IRC - Building

2022 GROUP B PUBLIC COMMENT AGENDA

SEPTEMBER 14 - 21, 2022
KENTUCKY INTERNATIONAL CONVENTION CENTER
LOUISVILLE, KY

FIGURE 1 - TOWNHOUSE LAYOUT

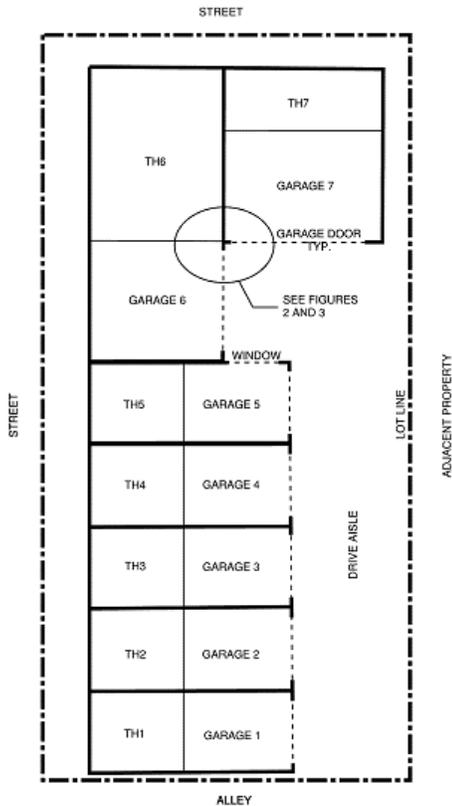
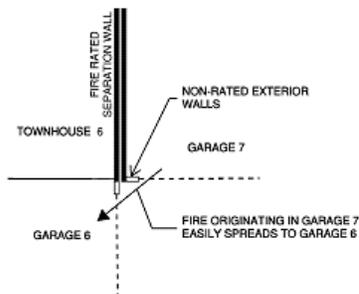
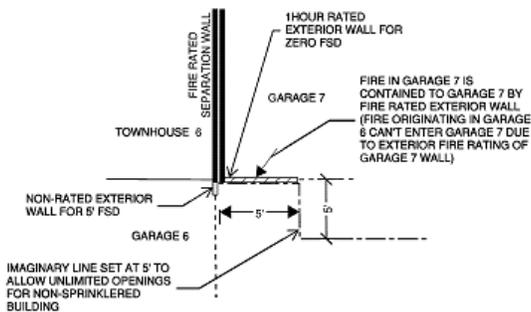
The figures below show the fire hazard this proposal is intended to address. Note that this configuration of townhouse units is from a real project - it is not hypothetical. Figure 1 shows the configuration of townhouse units on a lot where lot lines do not exist between units. Figure 2 shows exterior walls from two units that are perpendicular to each other with garage door openings adjacent to the intersection of these two walls. A fire originating in one garage could easily spread to the next since these large door openings are adjacent to each other (a similar condition occurs between Garage 6 door and Garage 5 window). Note that this condition is completely compliant with exterior wall requirements of the IRC since fire separation distance of these walls is measured to the lot lines of the lot the building is on. Figure 3 shows this same condition with an assumed imaginary line for fire separation distance, which results in a fire-resistance rated wall with no openings at this wall intersection, helping to prevent the spread of fire between units.

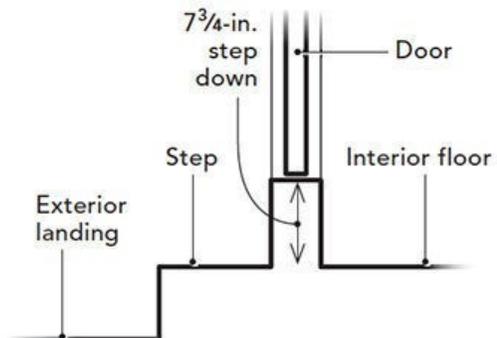
Reason: This proposal started as question – Can the landing or steps into a garage be the same as permitted for exterior doors or not? The following are current requirements - There is a requirement for landings at exterior doors (R311.3) and a requirement for landings at the top and bottom of stairways (R311.7.6). The required egress door has to open directly into a public way, yard or court (R311.1), so it has to be an exterior door. Egress is not permitted through a garage (R311.1).

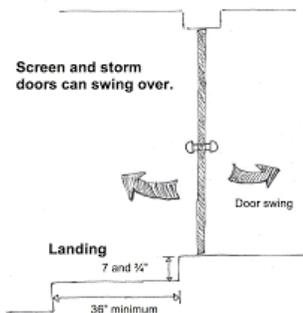
Was this not the intended allowance?

FIGURE R403.5(1) CRUSHED STONE FOOTINGS FOR CAST-IN-PLACE FOUNDATIONS IN SEISMIC DESIGN CATEGORIES A, B, AND C - MASONRY OR CAST-IN-PLACE CONCRETE FOUNDATION WALL

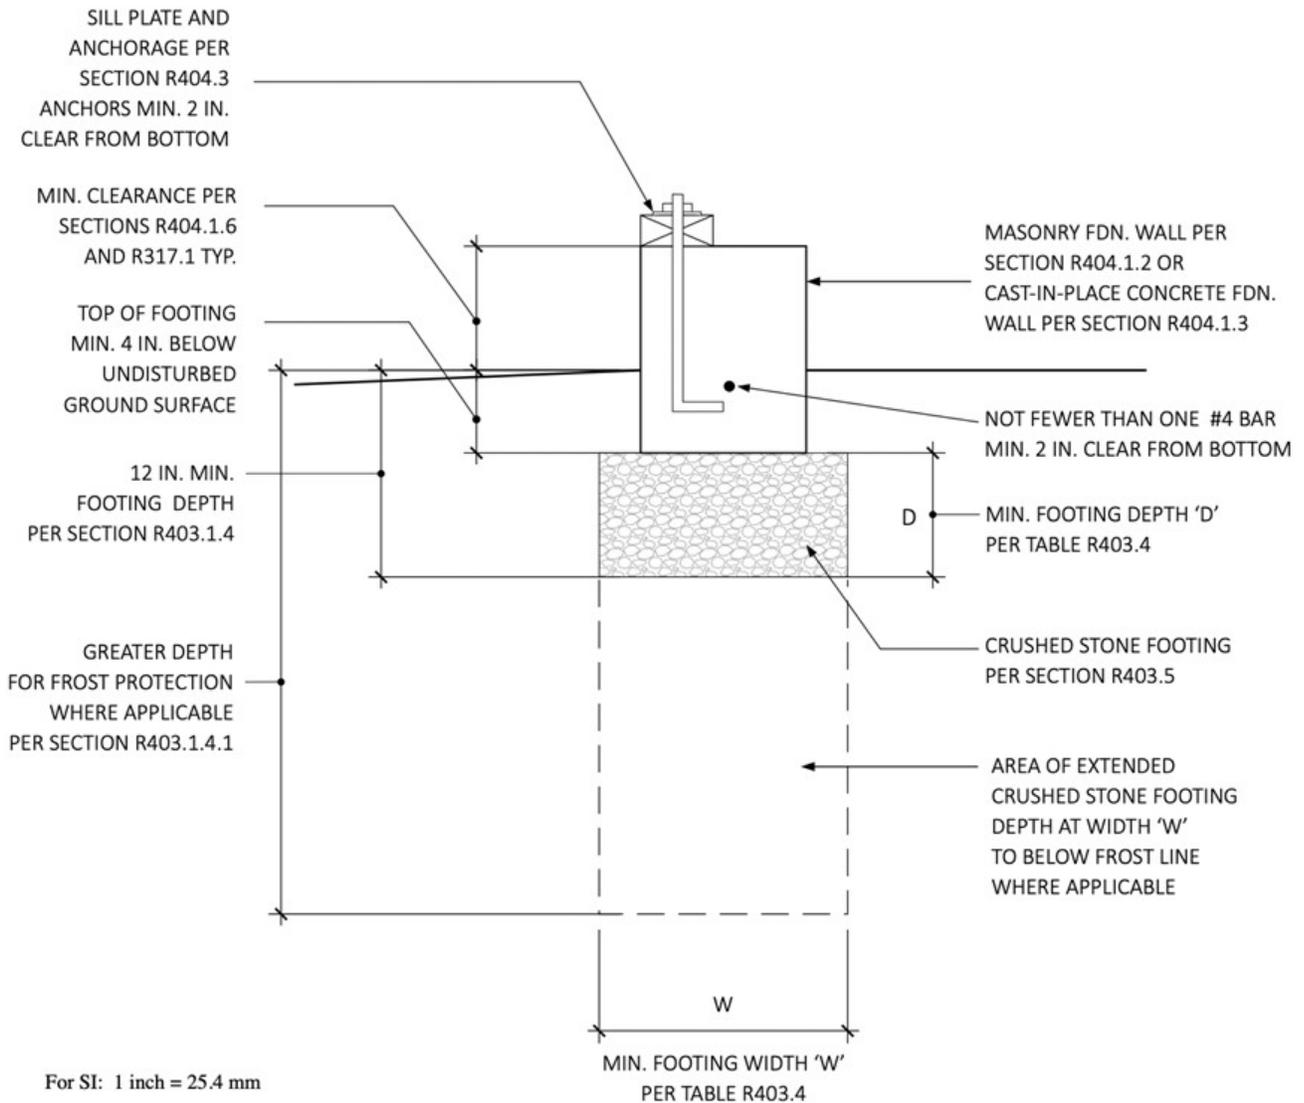
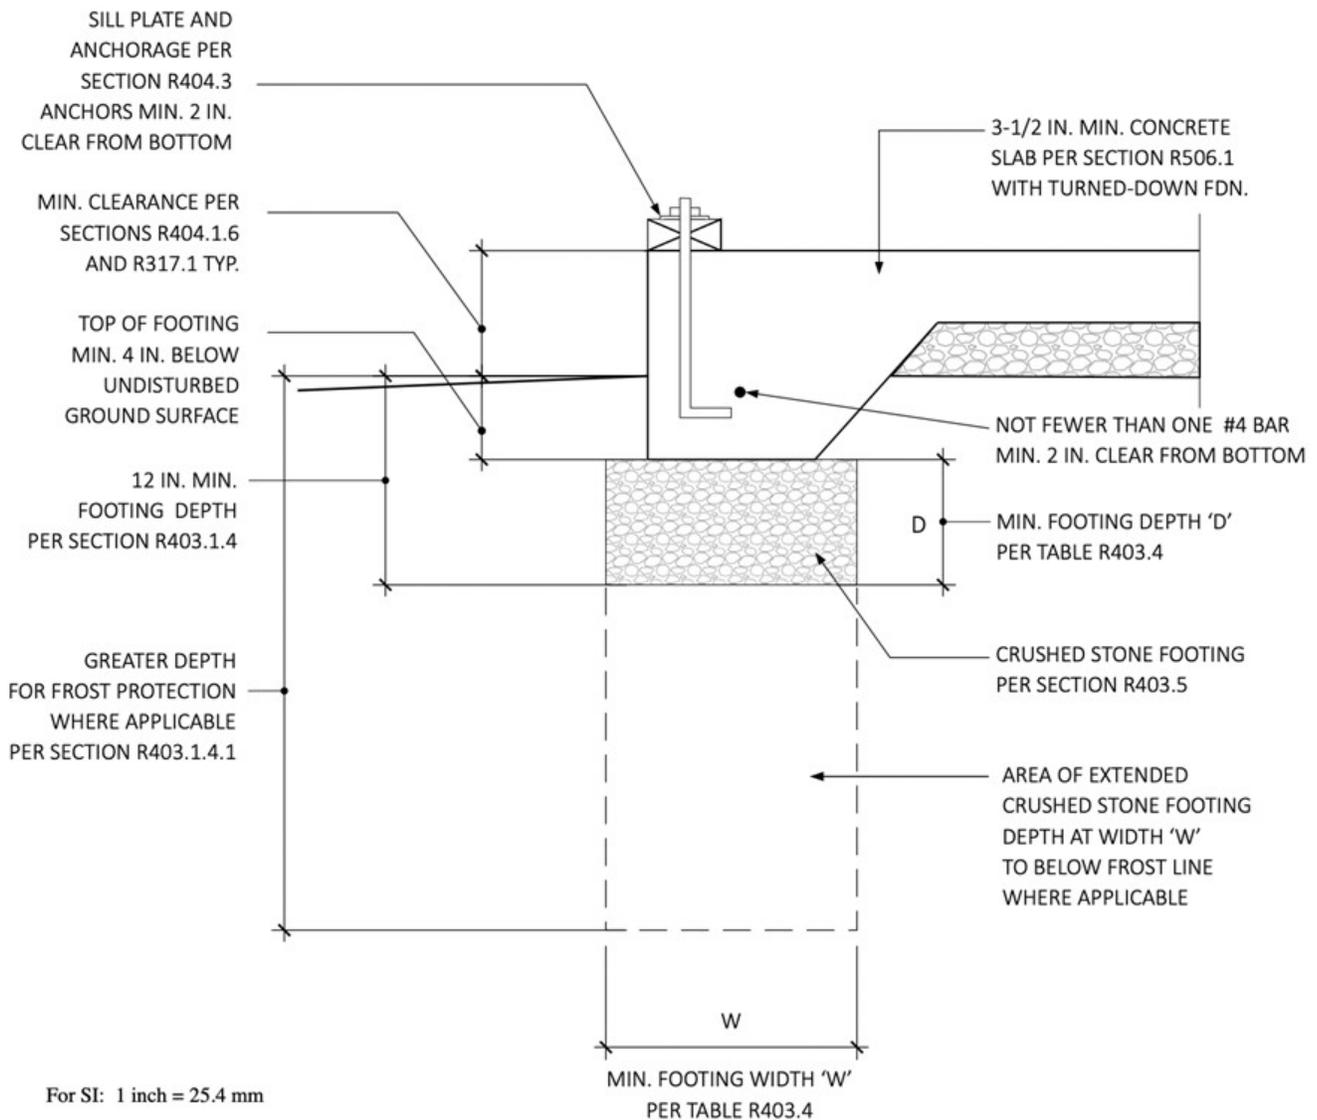
FIGURE R403.5
CRUSHED STONE FOOTINGS
FOR CAST-IN-PLACE FOUNDATIONS
IN SEISMIC DESIGN CATEGORIES A, B, AND C

FIGURE R704.2.1(1) TYPICAL SINGLE-SPAN VINYL SOFFIT PANEL SUPPORT

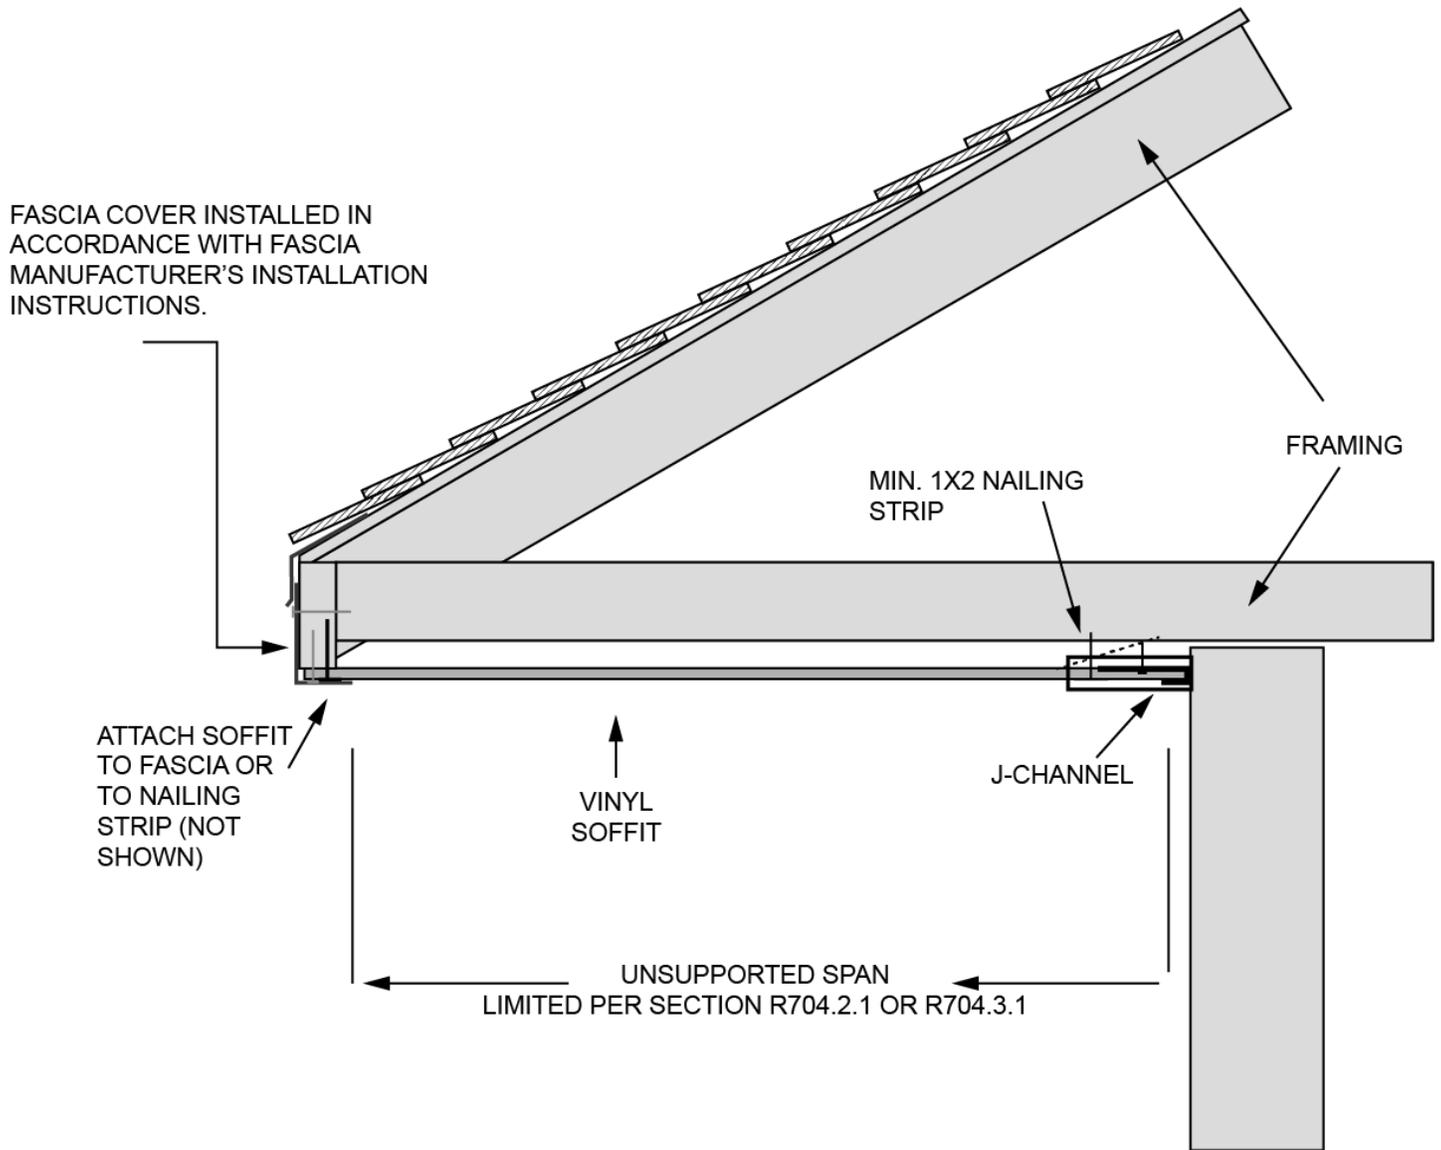
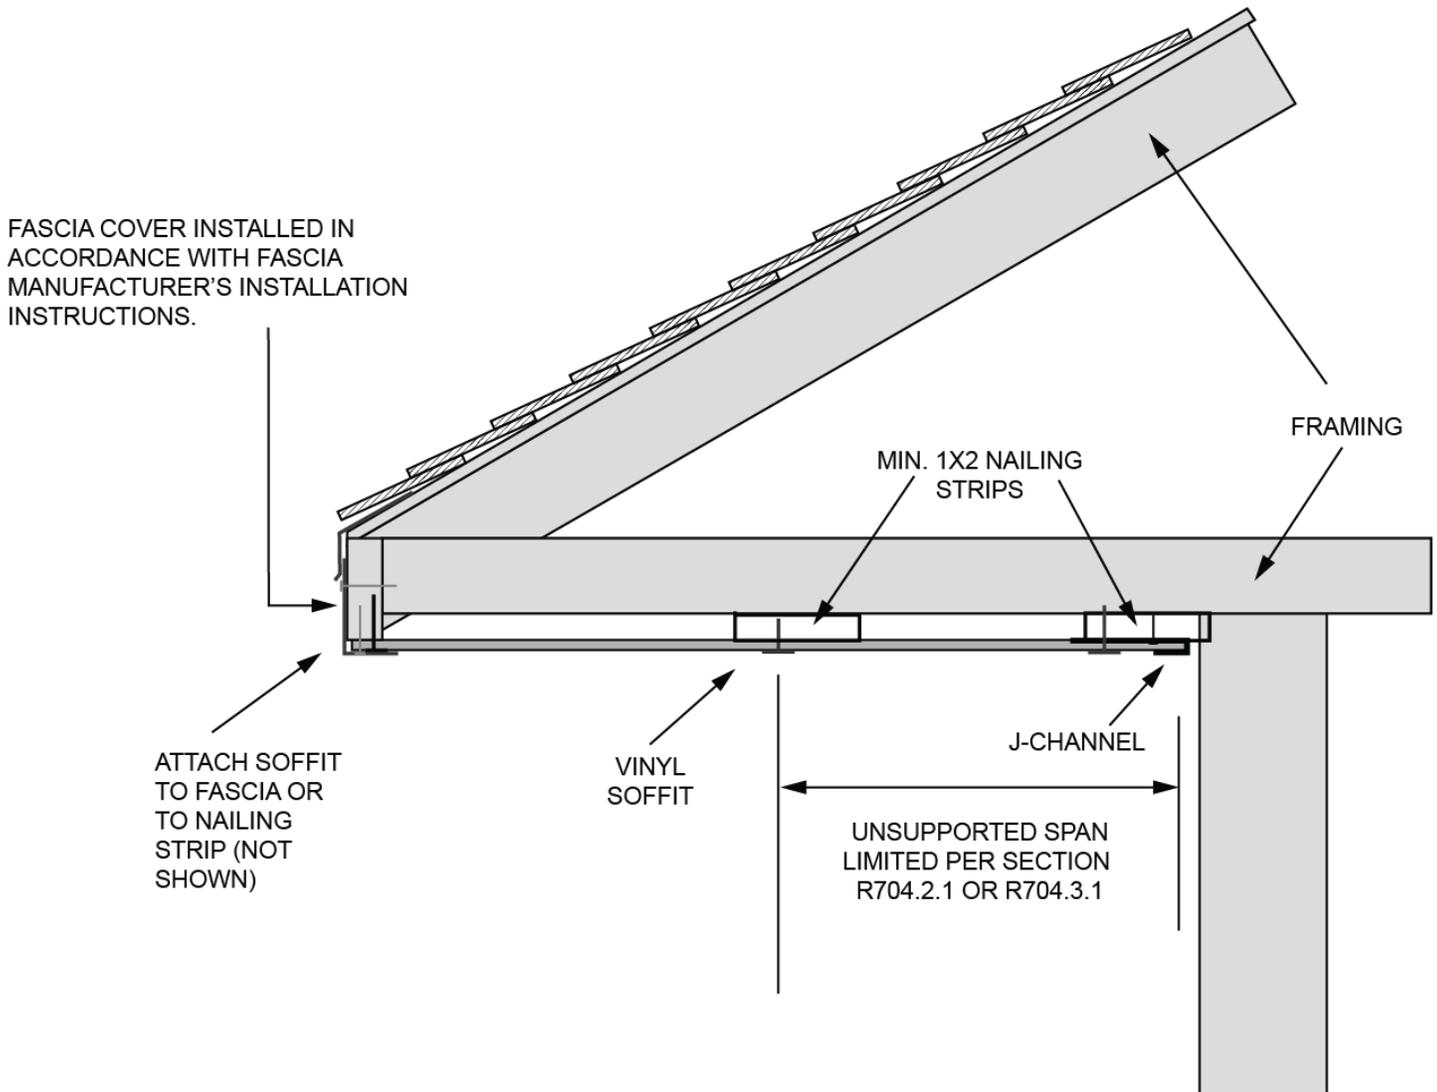
(Add 'exterior' in front of 'soffit' in three locations.)

Tee Fitting Clogged with Concrete and Tee Fitting Filled with Gravel

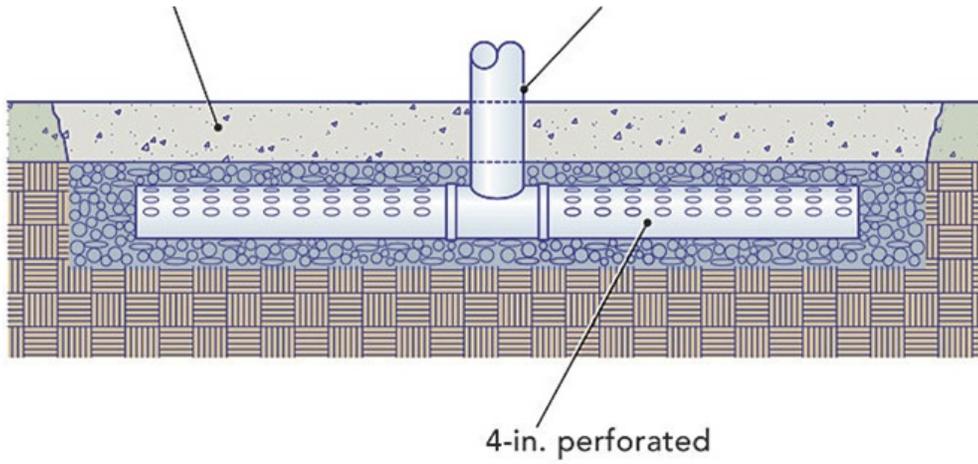
Commenter's Reason: This is a very common problem in the field where concrete from the slab pour leaks past the soil retarder and fills the "Tee Fitting". Gravel can also close off the "Tee Fitting" openings. Adding the pipe extenders keeps the suction point open.

FIGURE AY102.1(1) Extended Plate Wall (EPW) Construction, Section View

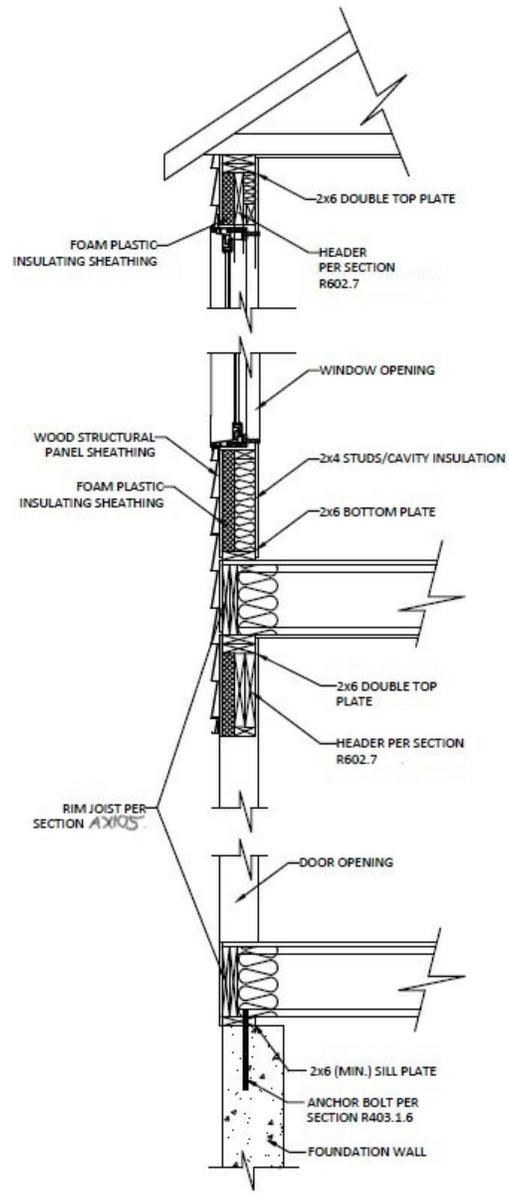
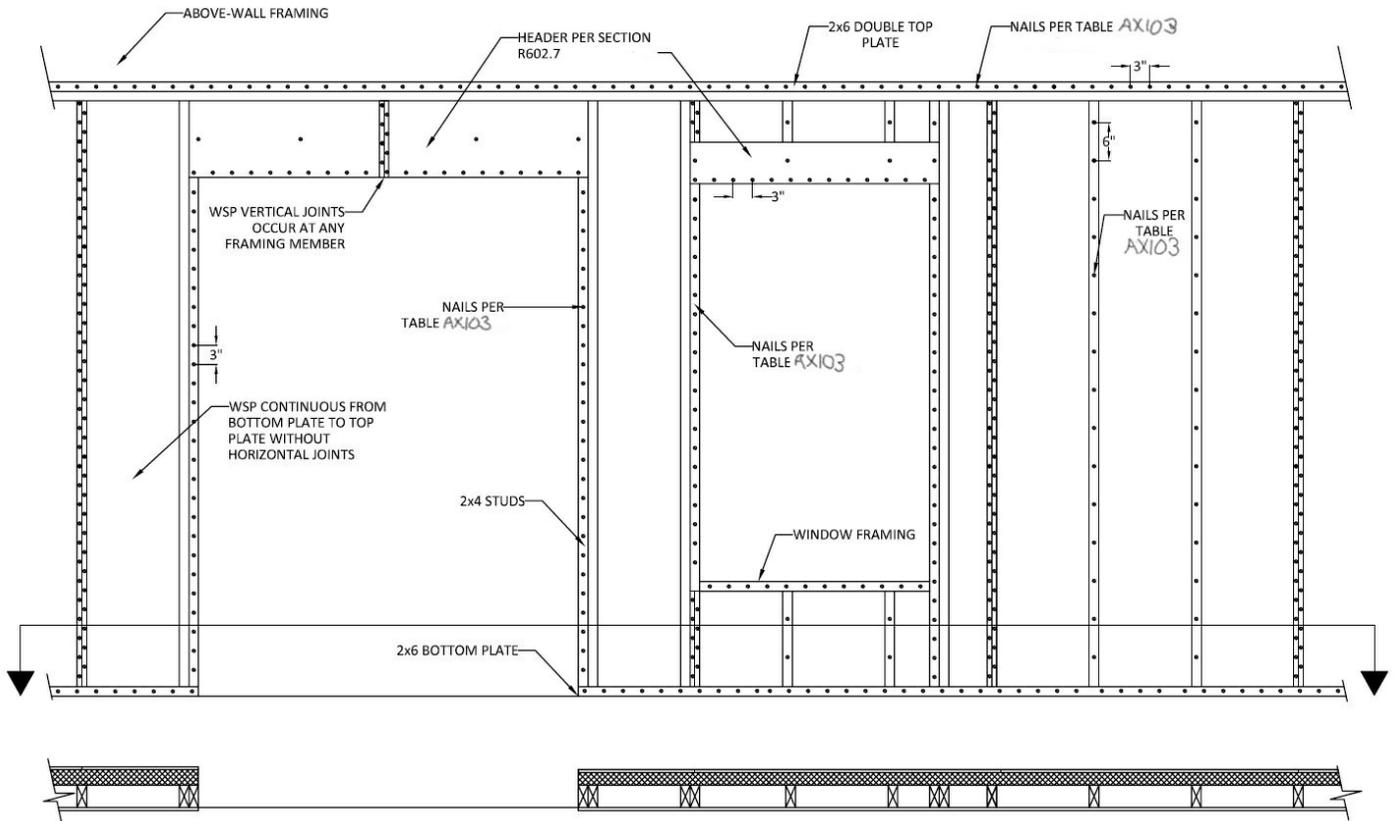
(Reference in note on bottom left should be to AY102.4)
